# 3787B-12

## S E R V I C E N O T E

### HP 3787B Digital Data Test Set

### Option 003 (Voice Channel Output) Retrofit

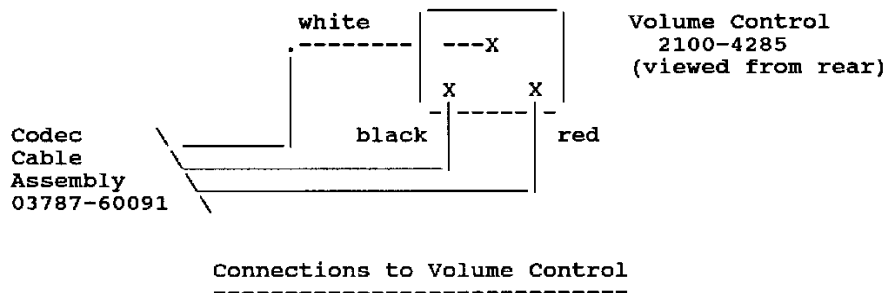
9. Solder the 3 wires from the codec cable assembly onto the volume control potentiometer as shown below.
10. Fit the potentiometer into the "MONITOR VOLUME" port and tighten the locknut.
